Development Facilitation Team (DFT) – Review Comments

Project No: PR-2021-005862 Date: 7/02/2025 Agenda Item: #10 Zone Atlas Page (M-08, N-08)

Request: Proposed 102 lot layout

Application For: PA-2025-00183 – SKETCH

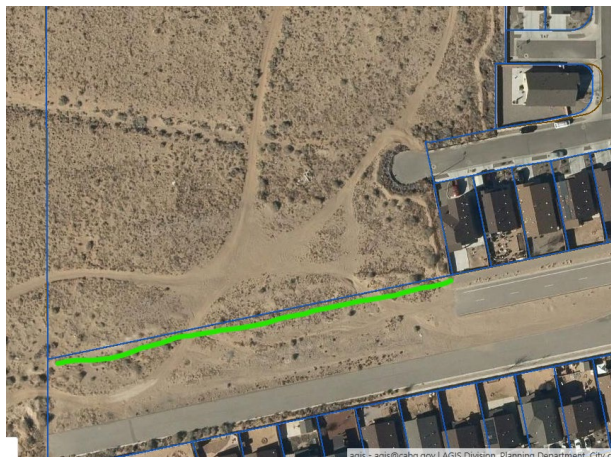
- Please provide 10' asphalt paved multi-use trail along the northern side of Gibson Blvd to connect to the existing trail to the east of the subject site. ~465 LF Please see the DPM for trail design standards. The trail is to be maintained by the property owner/HOA.
- IDO 5-3(D)(4) Trails
Trails shall be dedicated on alignments that connect to any planned or existing trails on adjacent properties, as necessary to serve the residents, occupants, and users of the proposed development, and shall be constructed pursuant to the DPM.

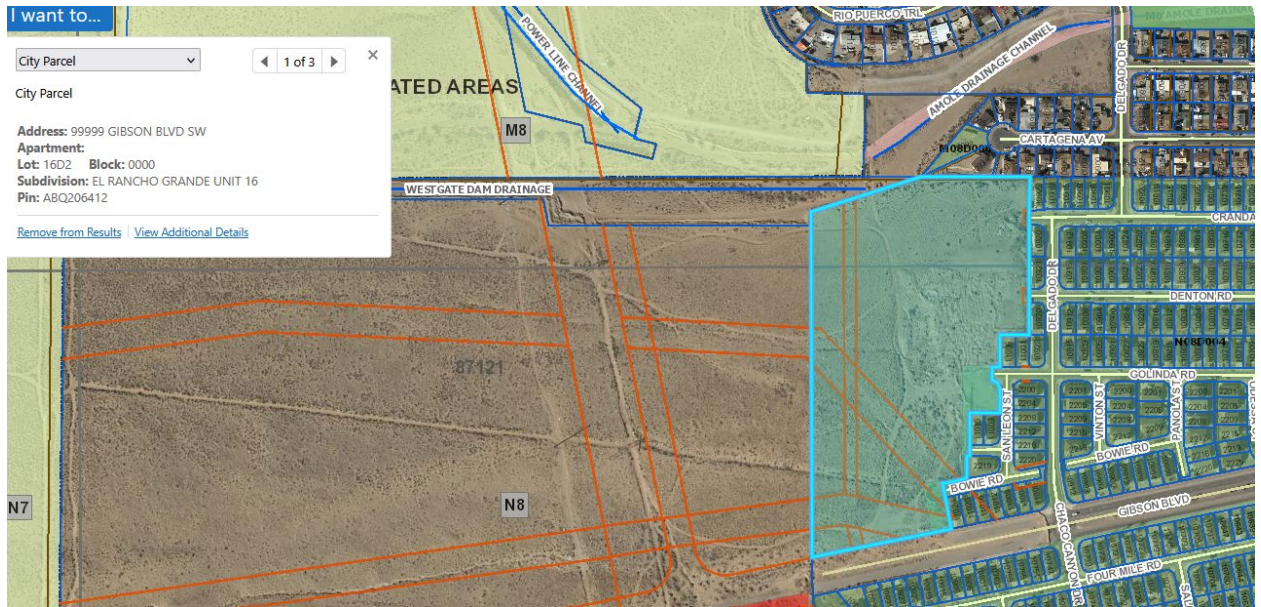
- Clarify existing easements, shown below in orange in AGIS maps:
